Determination 2019/063

Regarding the compliance of a paved path and retaining wall without a barrier with Clause F4 Safety from falling at 44 Hart Road, Richmond

This determination considers the compliance of a paved path and retaining wall without a barrier with Building Code Clause F4 Safety from falling. The determination discusses the measurement of the height of the fall.

Figure 2: Pool surround and upstand (from the inside)

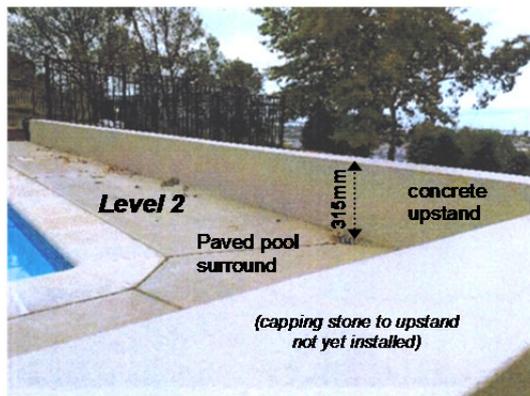
- The upstand provided to the retaining wall is able to be readily used by pool users (including young children) as a step or a seat. There is also a risk of slipping and tripping over the upstand to fall some 1500mm (including the capping).

Figure 4: The retaining wall

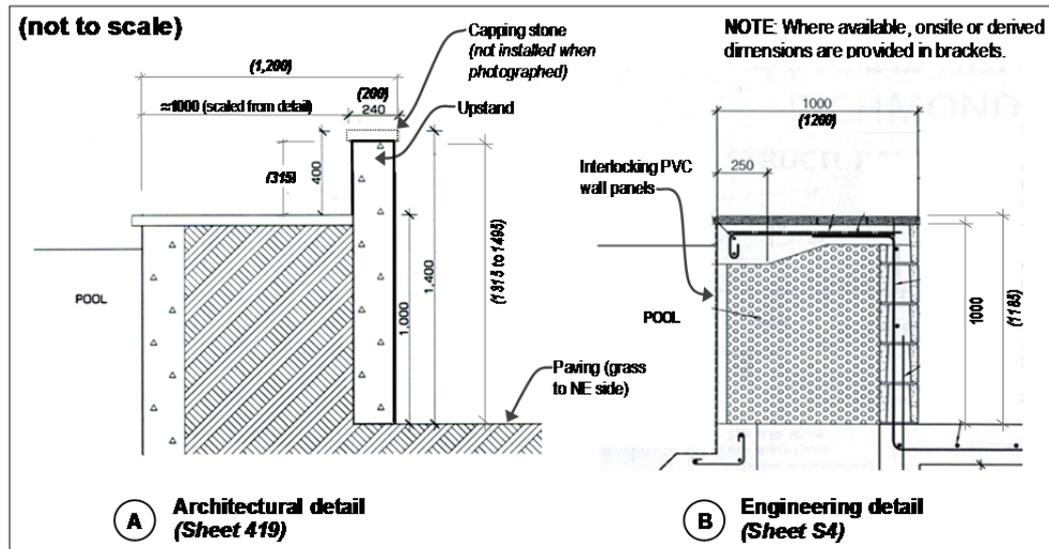
2.3.1 Details of the retaining wall in the consent drawings are shown in Figure 4, with the authority’s onsite measurements shown in brackets. As shown, a number of aspects and dimensions appear to conflict between the architectural details and the engineering details.

- 4.3.1 In considering the compliance with Clause F4.3.1 I must consider whether a fall of 1.0m or more could occur.
- 4.3.2 In paragraph 2.3.1 I referred to Figure 4 and noted a conflict in the design of the retaining wall between the architectural drawings and the engineer drawings, and as I have not seen a copy of the building consent it is not clear to me what proposal was granted with the building consent. Irrespective of the difference of design, both drawings show the vertical distance between the paved path and the lower level to be at least 1.0m, and in the case of the upstand (including capping) a 1.4m vertical distance between the top of the upstand of the retaining wall and the lower level. The authority's photos and onsite dimensions confirm this to be the case. I am satisfied in this case there is a fall distance of 1.0m or more.

2.3.2 Because the engineer's inspections included timber and concrete retaining walls and all aspects of the swimming pool (see paragraph 2.4.4), I have taken the engineering details to generally represent the as-built structure of the retaining wall – with the upstand added as two concrete block courses to the top of the retaining wall to reflect the architect's requirement.
